UNITED STATES PATENT AND TRADEMARK OFFICE

Office Action Summary	Application No. 10/565,892	Applicant(s) LEWIS ET AL.	
	Examiner Brent T. O'Hern	Art Unit 1794

DETAILED ACTION

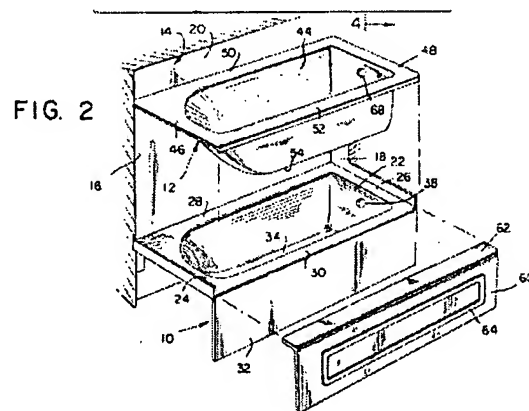
14. The phrase “wherein a ratio of thickness of the acrylonitrile butadiene styrene material to the acrylic cap is 9:1” in claim 47, lines 2-3 is vague and indefinite since it is unclear whether the “cap” is referring to something that someone wears, a polymer, a wall or something else and is where is the “thickness”.

15. Claim 47 recites the limitation “the acrylic cap” in lines 2-3. There is **insufficient antecedent basis** for this limitation in the claim.

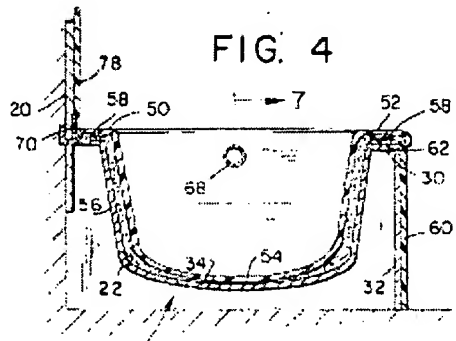
Regarding claims 41 and 52-56, Altman ('071) teaches a composite article having an upper member of plastics material having an undersurface (See col. 4, ll. 3-7 and FIG-2, #12 with an undersurface.) and

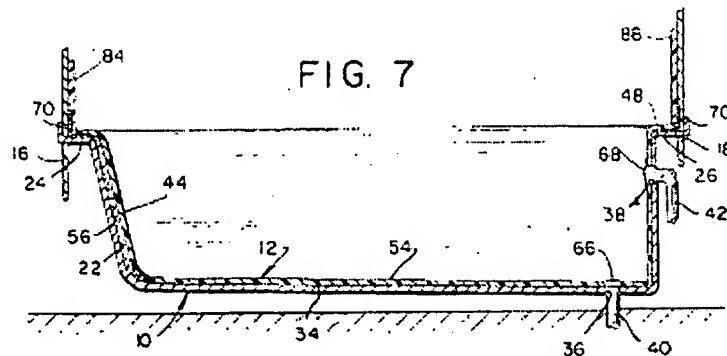
a lower member of plastics material that together form an outer shell (See FIG-2, #60, #10 and col. 7, ll. 3-5.), and an inner core of filler within the shell (See FIGs 4 and 7, #56.), the upper member being spaced from the lower member to define a gap therebetween,

the gap being constructed and arranged to separate the upper member from the lower member, to receive the core, and to provide strength and rigidity to the article and wherein the core extends between the upper member and the lower member to support substantially the entire undersurface of the upper member (See FIGs 4 and 7 and col. 6, ll. 11-17 wherein the upper/lower members are spaced with core #56 between and wherein the core substantially supports the undersurface. Furthermore, Applicant has not disclosed what substantially means.).
